Credit Procedure: Reimbursement of Oil Pump Replacement

Bulletin number M1450 must be entered into the comments section of the claim.

Figure 1. Cam Support Plate Tightening Sequence

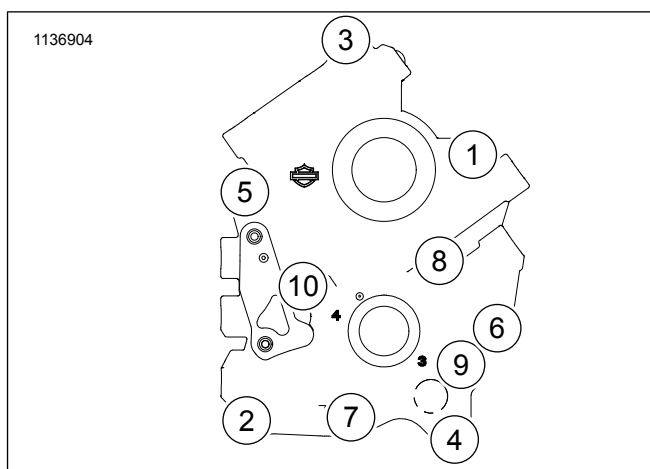
1. Install cam support plate. See the service manual.
2. Refer to Figure 1. Follow modified tightening sequence.
Torque: 10.4–12.7 N·m (92–112 **in-lbs**)
 - a. Tighten screws 1-6.
 - b. Rotate crankshaft 360°.
 - c. Tighten screws 7-10.
